UNITED STATES PATENT AND TRADEMARK OFFICE

APPLICATION NO.	FILING DATE	FIRST NAMED INVENTOR	ATTORNEY DOCKET NO.	CONFIRMATION NO.
10/575,052	04/02/2007	Malcolm Lambert	DP-310801	9228
22851 7590 08/21/2009 DELPHI TECHNOLOGIES, INC. M/C 480-410-202 PO BOX 5052 TROY, MI 48007				
EXAMINER				
JONATIS, JUSTIN M				
ART UNIT		PAPER NUMBER		
3752				
MAIL DATE		DELIVERY MODE		
08/21/2009		PAPER

Office Action Summary

DETAILED ACTION

Exhibits A and B presented by Applicant in Office Action response Filed 05/26/2009

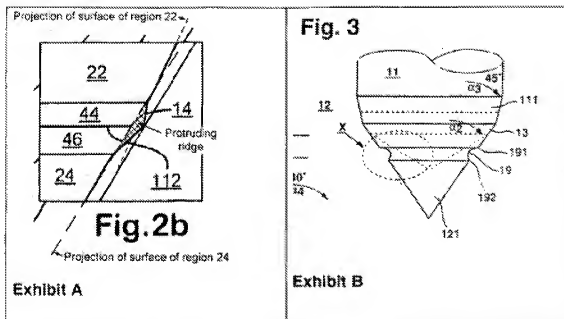
In regard to claims 1-4, applicant submits Exhibits A and B (see above), and states that the Danckert et al. reference's seating line is defined by the intersection of two regions and not the additional raised ridge disclosed in the applicant's Figure.

Examiner would like to point out that the seating line of the applicant's figure is provided by the intersection of two regions, which are Upstream Ridge Region (44) and Downstream Ridge Region (46) in the same manner that Danckert's lower half of the transition surface (111) and the top half of the sealing surface (13) form a seating line.

Exhibit B provided by Applicant appropriately Resized

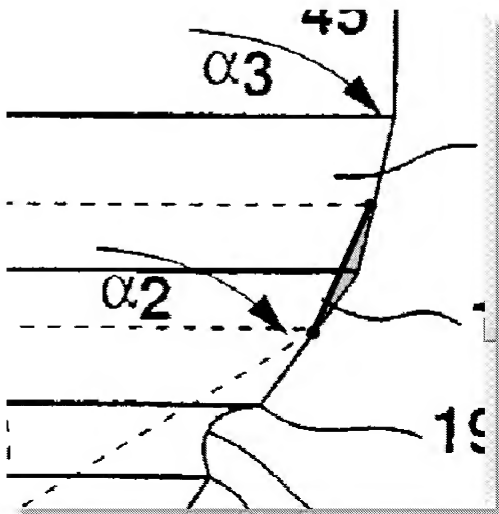
Examiner would also like to present Exhibit B in a more appropriately scaled form to compare to applicant's Exhibit A in order to clarify why the Danckert reference is not deficient in defining the protruding ridge.

In the zoomed view of Exhibit B, a line was added to connect the outer wall of the mid section of the transition surface (111) and the seating surface (13), and the protruding portion was greyed out to more clearly define itself. Clearly it can be seen that the surfaces of Danckert disclose a protruding ridge provided by the lower half of transition surface (111) and the top half of seating surface (13) in the same manner as applicant's protruding ridge is defined by the upstream ridge region (44) and the downstream ridge region (46)
